ADDENDUM 1 – JOB 22957

TO: All prospective bidders on Projects IM-X-1-094(214)162, Job No. 22957 scheduled for the November 15, 2024 bid opening.

PLAN ADDENDUM SUMMARY AND APPROVAL

PROJECT INFORMATION		
Project:	IM-X-1-094(214)162	PCN: 22957
Location:	BURLEIGH CO; I-94, BISMARCK E TO E OF MENOKEN - EB	
Date:	11/7/24	Lead Designer: Apex Engineering Group
Bid Opening Date:	11/15/24	JOB#: 22957 Addendum#: 1

Proposed Typical Sections
EB Mainline

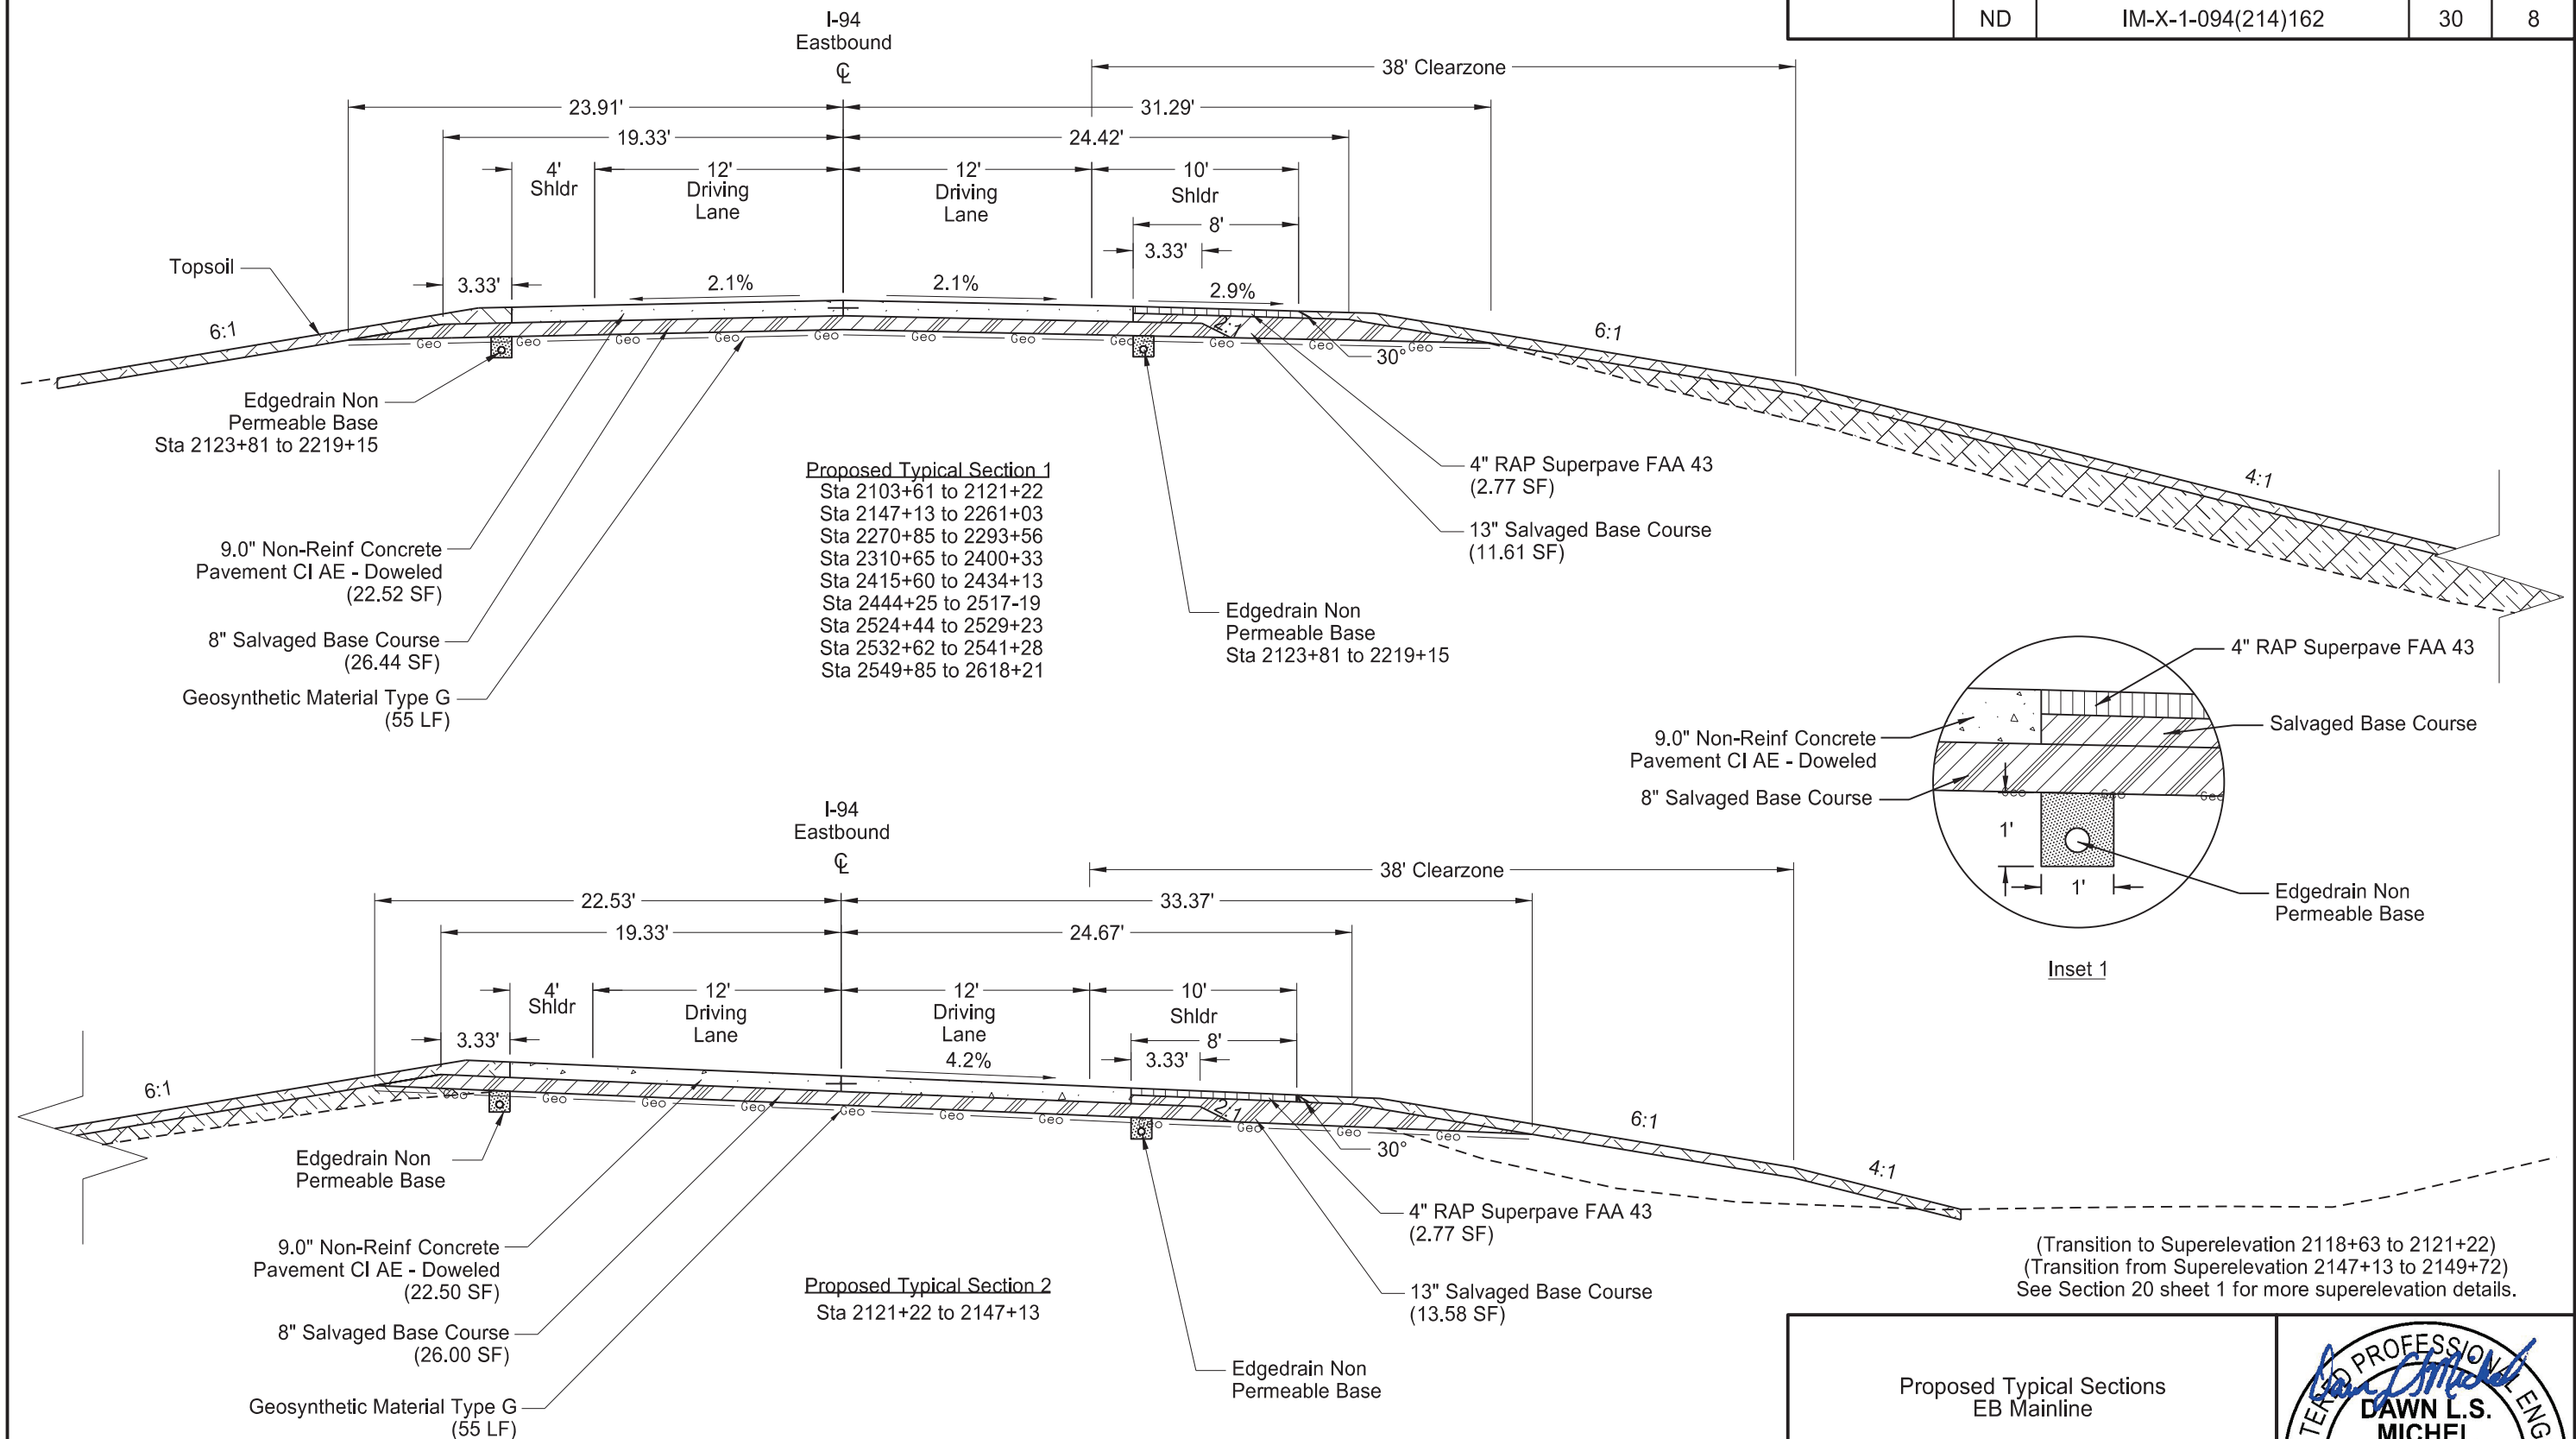
8	4	Revised quantity for SHORING Added bid item REMOVAL OF SHORING
10	1	Revised 9IN NON-REINF CONCRETE PVMT CL AE-DOWELED and GEOSYNTHETIC MATERIAL TYPE G quantities in Typical 5
10	2	Revised 9IN NON-REINF CONCRETE PVMT CL AE-DOWELED and GEOSYNTHETIC MATERIAL TYPE G quantities in tables
10	3	Revised 714-9720 UNDERDRAIN PIPE PVC PERFORATED 4IN summary table to 714-9696 EDGEDRAIN NON PERMEABLE BASE summary table
20	2	Revised dowel bar locations in plan view
20	5	Replaced Mainline Widening CL Pipe Extension Detail Sheet with Removal of 72" Culvert Detail Sheet
20	6 & 8	Revised detail and added REMOVAL OF SHORING quantity
20	14	Revised ECB Table for new pipes
20	15	Added rest area to dowel bar and tie bar charts
20	17	Revised riprap and geosynthetic table
30	8	Revised UNDERDRAIN PIPE PVC PERFORATED 4IN to EDGEDRAIN NON PERMEABLE BASE in typicals. Also updated location of edgedrain in proposed Typical Section 2.

Revised	11/7/2024	STATE	PROJECT NO.	SECTION NO.	SHEET NO.
		ND	IM-X-1-094(214)162	50	1

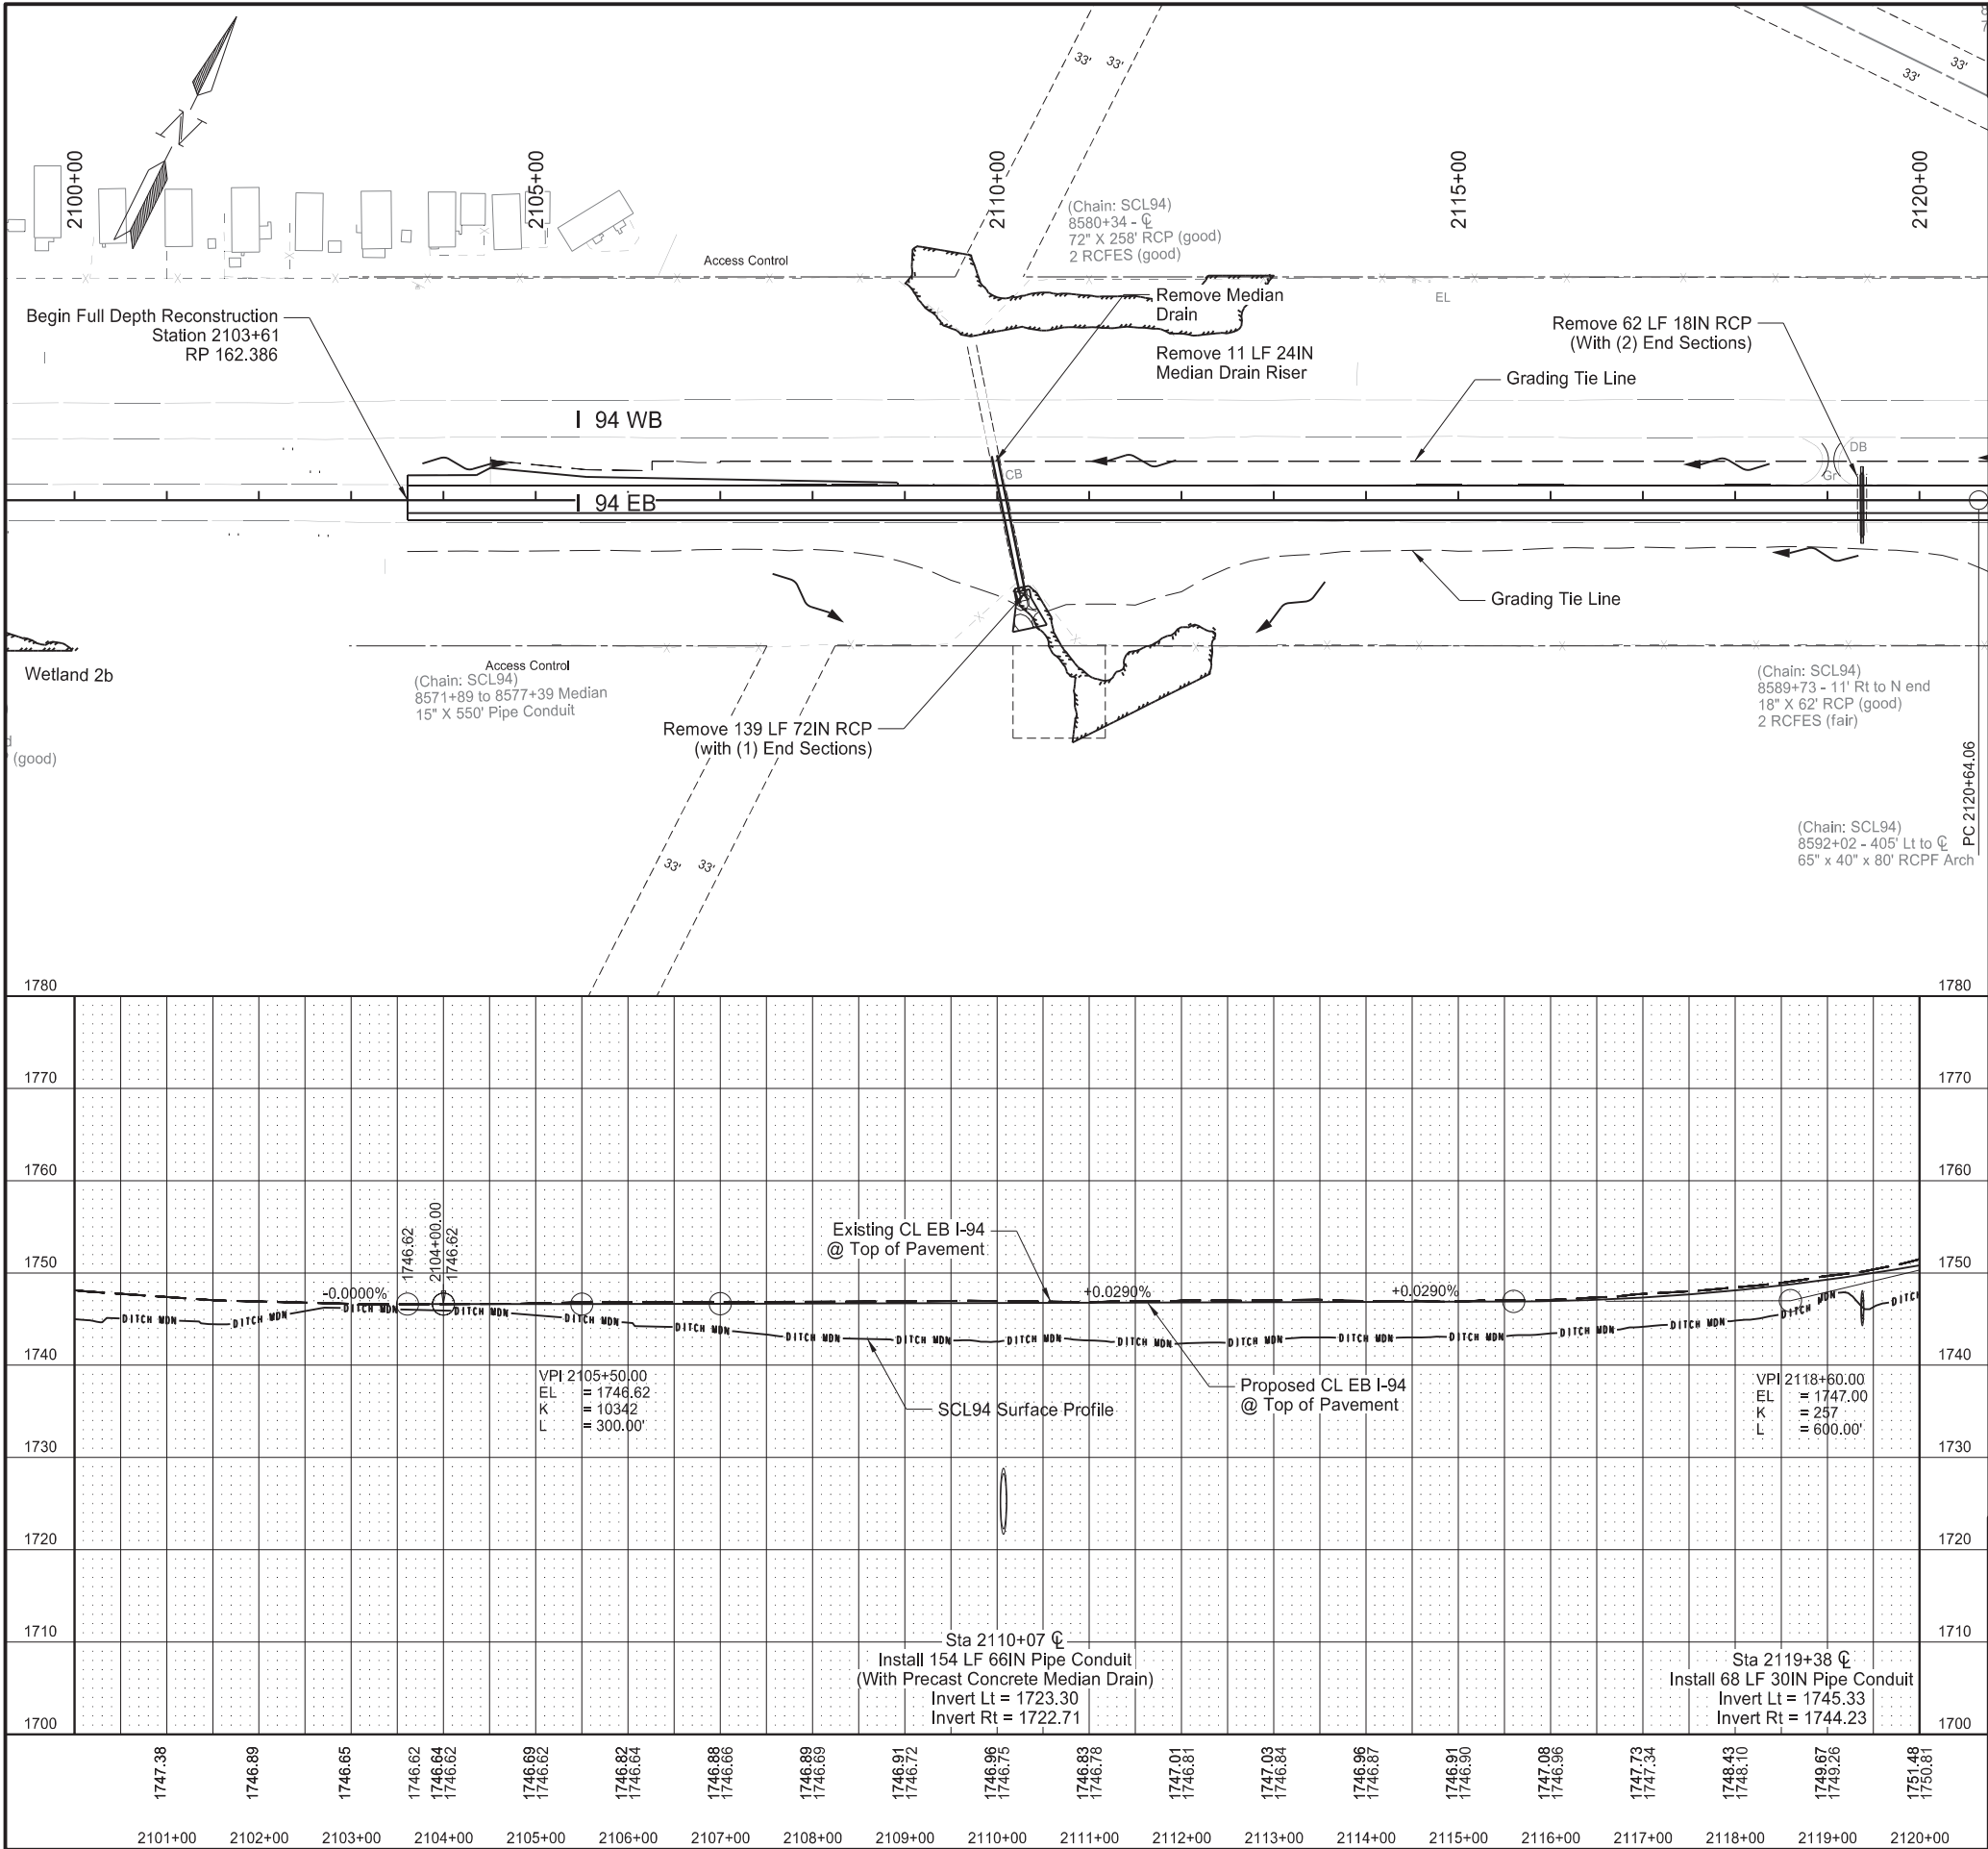
50	1	Revised hydraulic information on new pipes
51	1-2	Revised all pipe extensions to new pipe installations.
60	All	Reprinted sheets to show new culvert installations.
75	All	Reprinted sheets to show new culvert installations.
77	All	Reprinted sheets to show new culvert installations.
90	2-6	Revised dowel bar locations in plan view
100	1	Revised quantity for ATTENUATION DEVICE TYPE B-75, OBLITERATION OF PVMT MK and STATE FURNISHED MEDIAN BARRIER. Changed SHORT TERM 6IN LINE – TYPE NR to SHORT TERM 6IN LINE – Type R
100	10	Revised SHORT TERM 6IN LINE – TYPE NR to SHORT TERM 6IN LINE – Type R
100	11	Revised SHORT TERM 6IN LINE – TYPE NR to SHORT TERM 6IN LINE – Type R
100	19	Revised OBLITERATION OF PAVEMENT MARKING quantity and revised bid item and references for PVMT MK PAINTED 4IN LINE to PVMT MK PAINTED 6IN LINE
100	20	Added Pipe Work Area at STA 2110+07, Revised quantity for ATTENUATION DEVICE TYPE B-75 and STATE FURNISHED MEDIAN BARRIER
